ALDE AND ORE ESTUARY ASSESSOR'S REPORT

NAME: John Grayburn	DATE OF INSPECTION Spring 2016
LOCATION: Flood Cells 6 and 7	SPRING 2016
Area of Assessment: FC6 South bank from tidal sluice to end of Maltings defences at TM393 573 FC7 North bank from tidal sluice to rising ground at TM401 576	Send to

Picture 1: TM396 577 looking East Slope in footpath

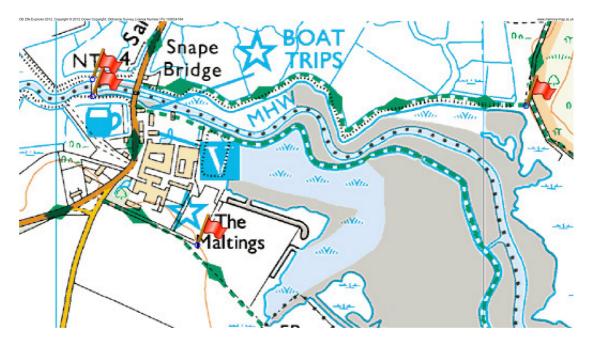
Repairs to the wall from the B1069 at Snape bridge to the higher ground at TM401 576 following the December 2013 surge have been completed. The repairs are standing up well but there is some slippage of the regraded rear face as evidence by the lateral slope in the top footpath (see picture 1).
